APPEAL SUMMARY

Appeal ID: 20546	Project Address: 1600 SW Salmon St
Hearing Date: 6/19/19	Appellant Name: Tom Jaleski
Case No.: B-017	Appellant Phone: 503.488.5651
Appeal Type: Building	Plans Examiner/Inspector: Jody Orrison
Project Type: commercial	Stories: 6 Occupancy: A-2, A-3, B, E, S-1 Construction Type: I-B
Building/Business Name: Lincoln High School	Fire Sprinklers: Yes - Throughout
Appeal Involves: Erection of a new structure	LUR or Permit Application No.:
Plan Submitted Option: pdf [File 1] [File 2]	Proposed use: High School - Main Building

APPEAL INFORMATION SHEET

LINCOLN HIGH SCHOOL REPLACEMENT

SECOND AND THIRD FLOOR PLAN OVERALL

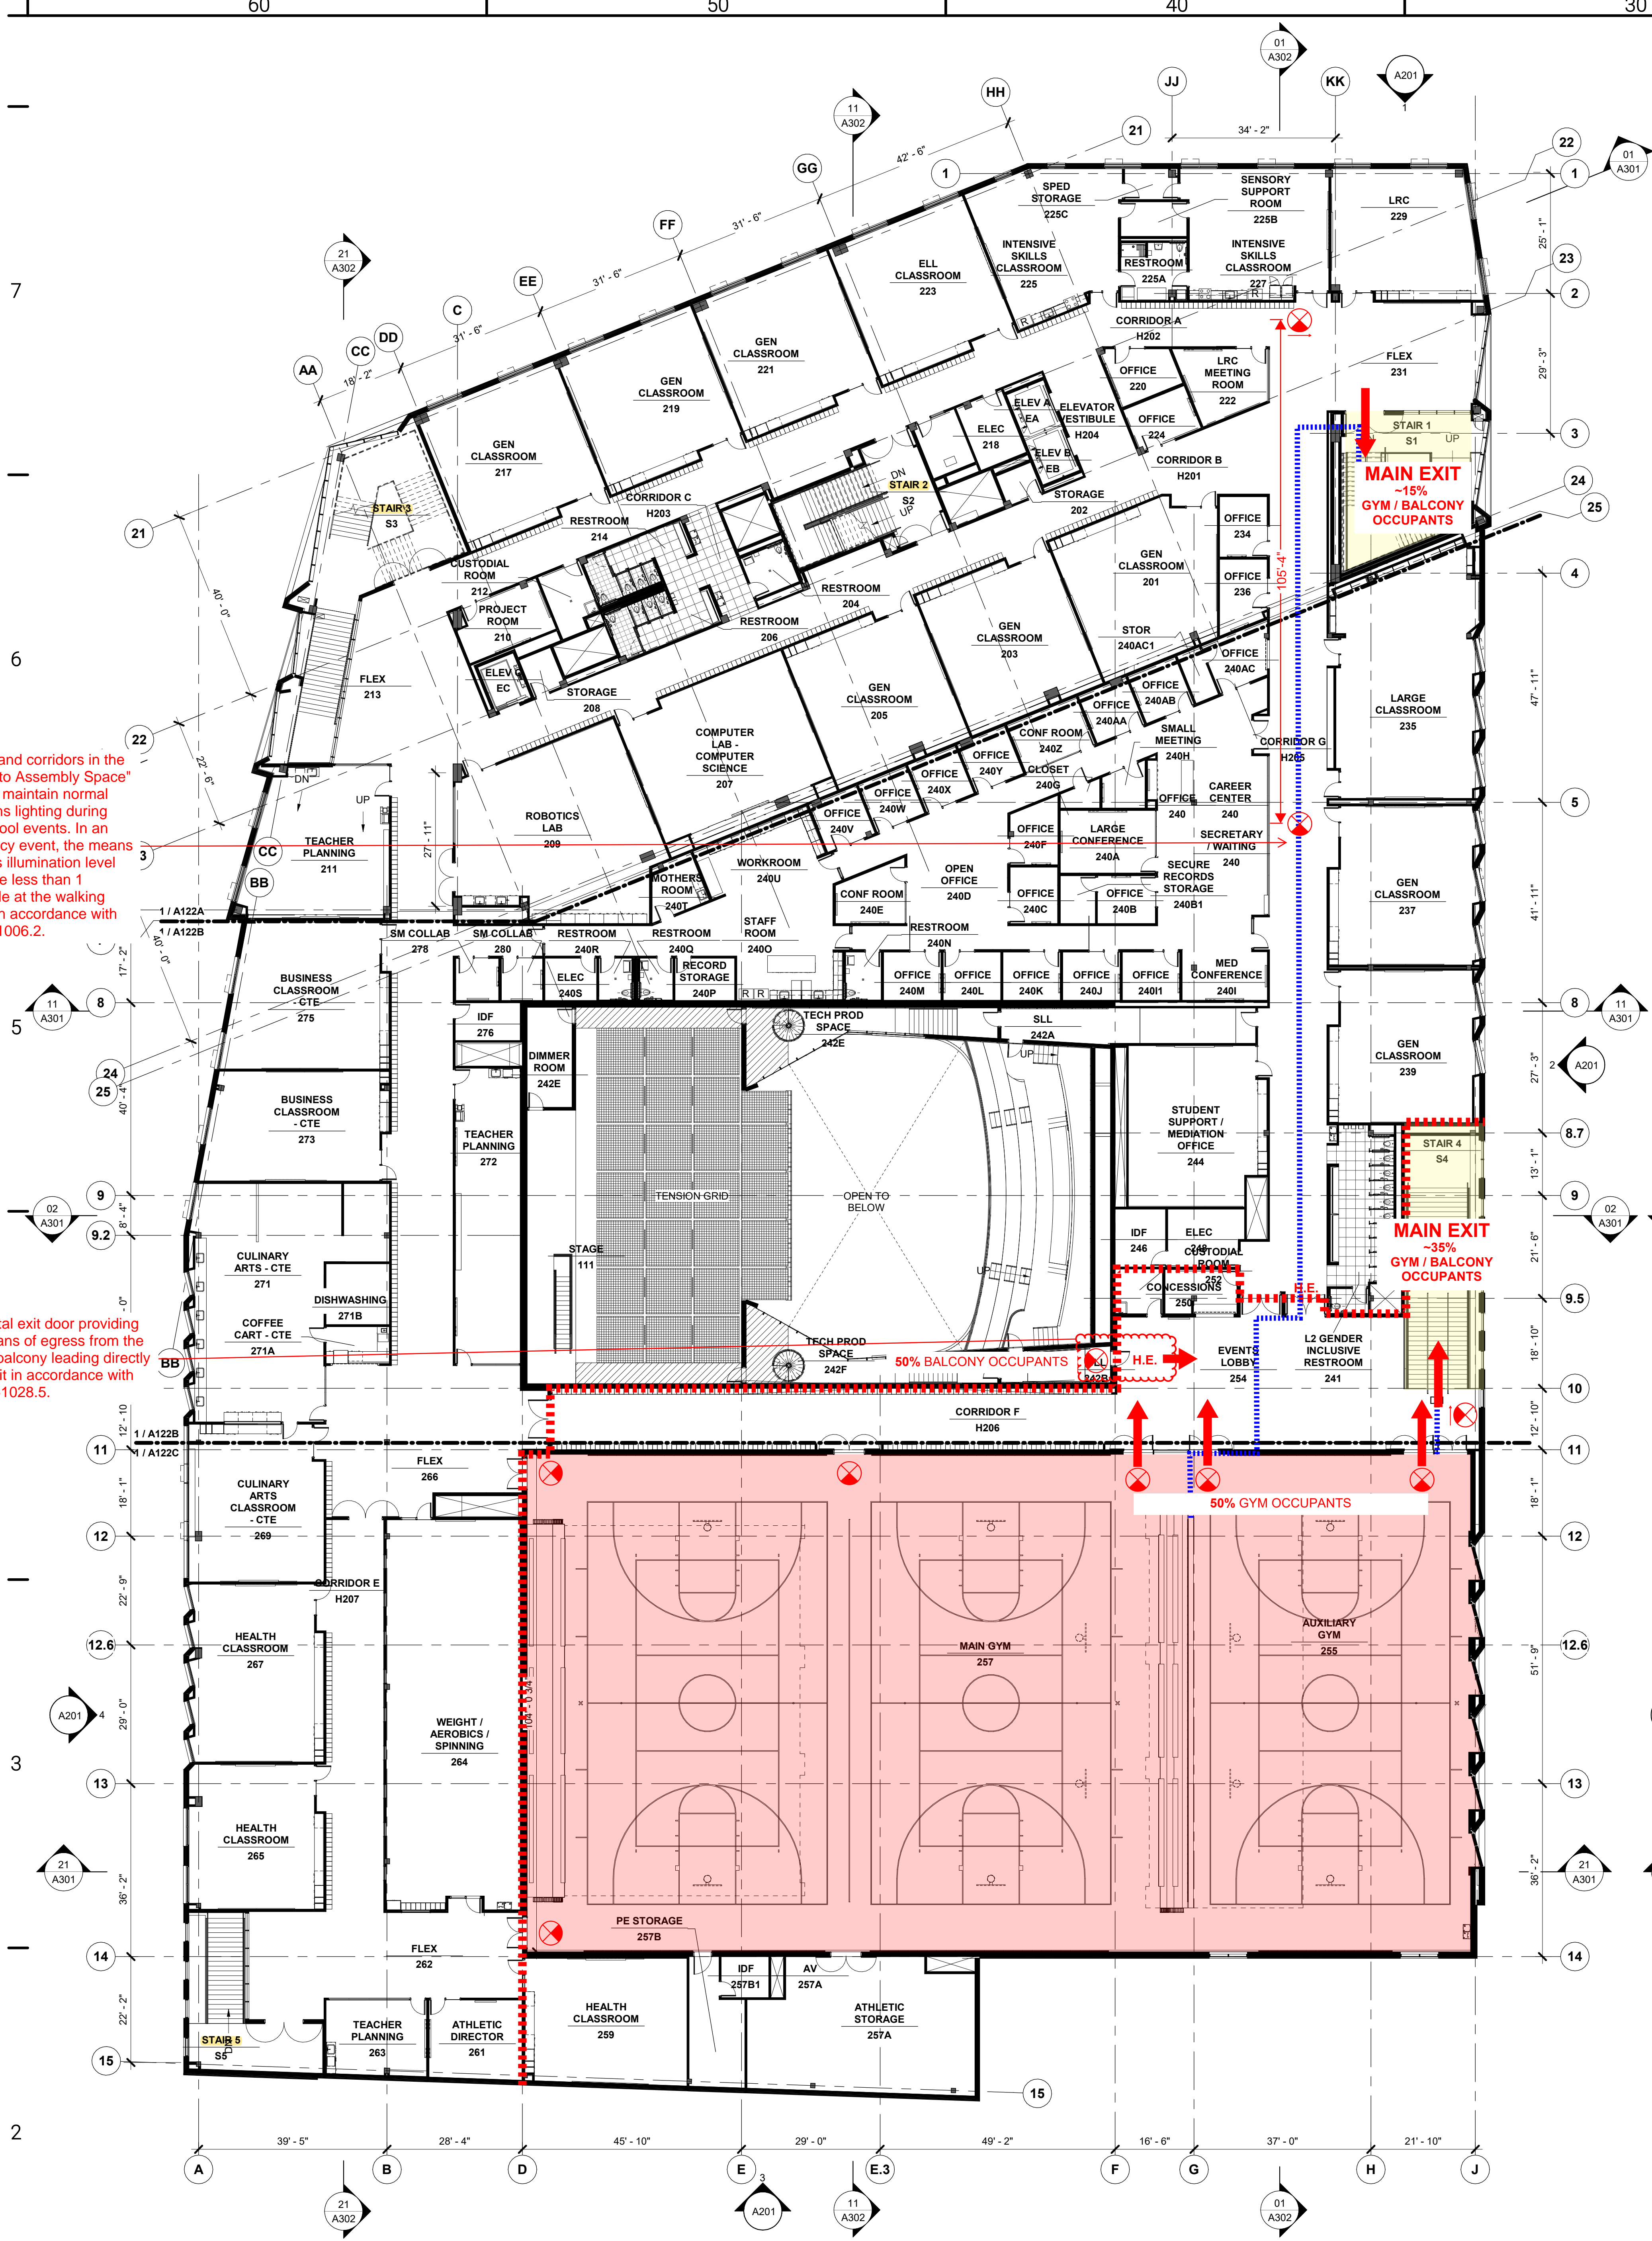
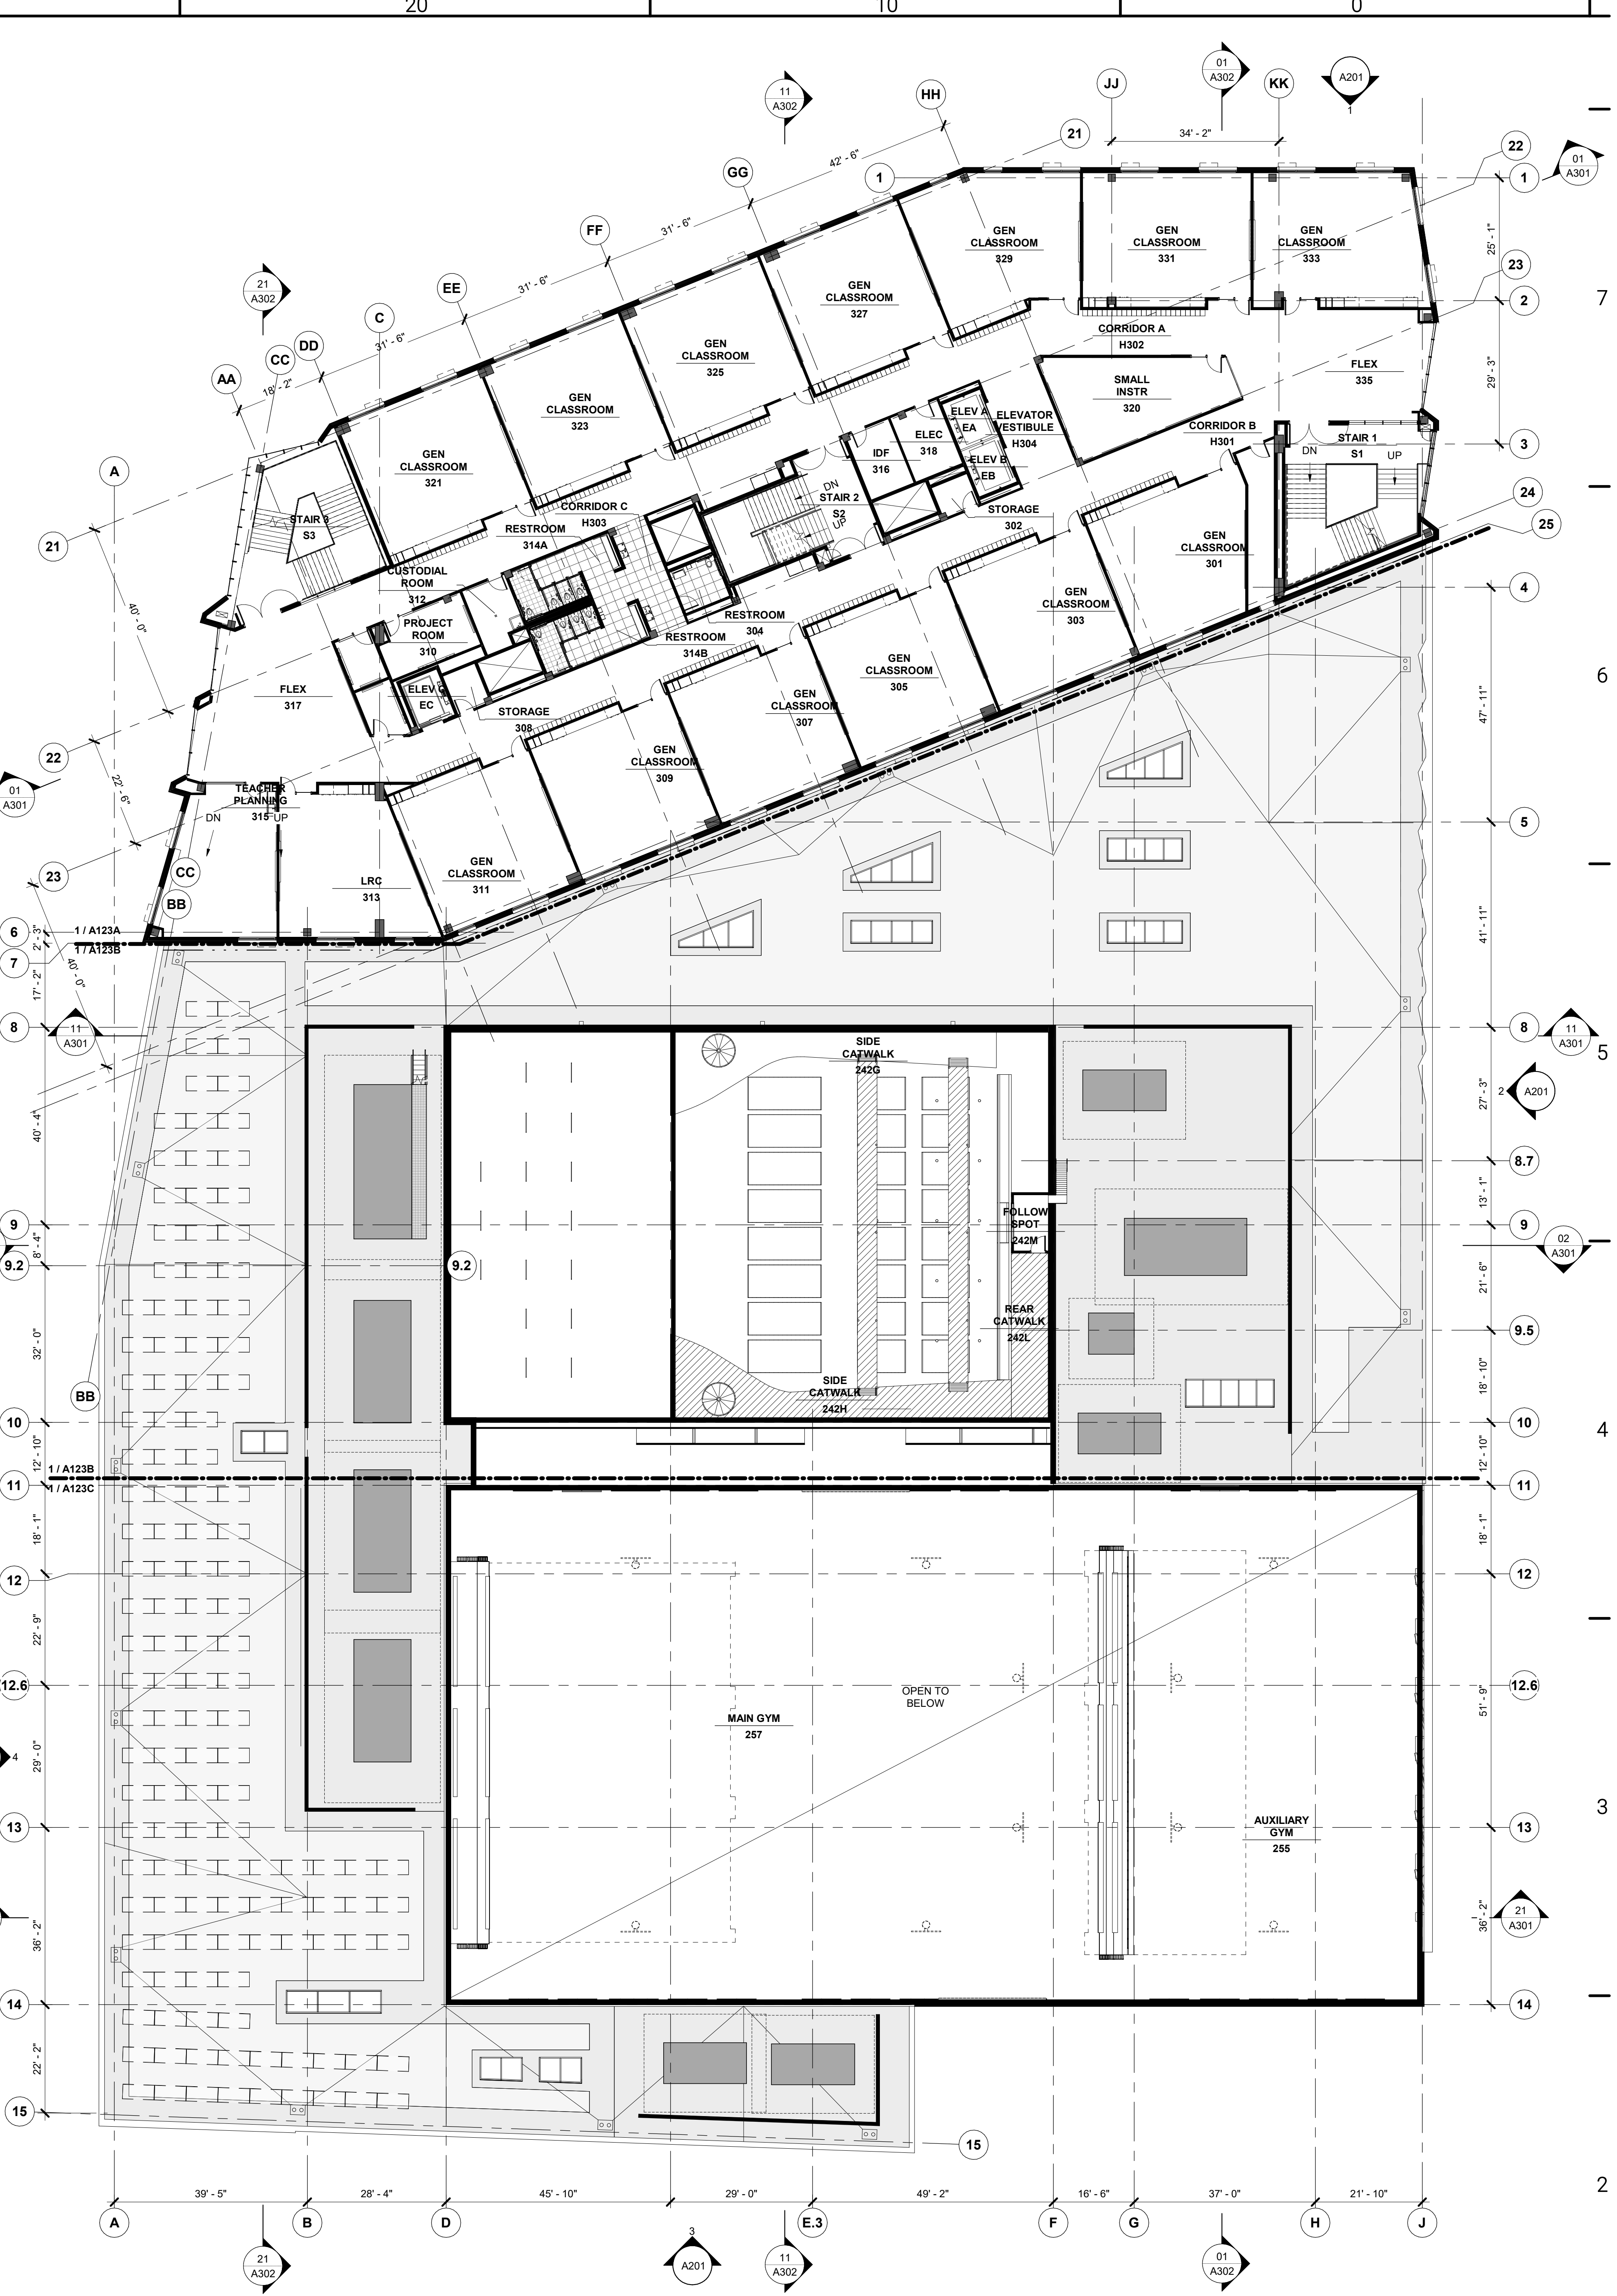
Proposed Design Lincoln High school will feature two assembly spaces on Level 02, the Theater Balcony and Gym, with a combined occupant load of over 300 occupants.

Per §1028.2, these assembly spaces must be provided with a main exit. This is typically accomplished through the main entrance, as there is a tendency for occupants to exit the same way they entered the space. The proposed design has two points of entry; therefore, it is proposed that the assembly spaces be served by two main exits: Stair 1 discharging to SW Salmon Street and Stair 4 discharging to the east side of the building.

As well, per §1028.3, assembly spaces provided with a main exit must also be provided with a second means of egress that accommodates at least one-half of the occupant load served by that level; this is accomplished through the remaining stairs distributed around the building at Level 02.

Therefore, due to the anticipated use of the building and mitigation measures providing equivalent fire life safety protection, it is requested that the two (2) stairways used for access to the assembly spaces on Level 02 be allowed to both serve as the “Assembly Main Exit” to meet the requirements of §1028.2 and that the remaining stairs distributed on Level 02 be allowed to serve as the “Assembly Other Exits” to meet the requirements of §1028.3.

1. Assembly occupancy with 2 main exits: Hold for additional information.
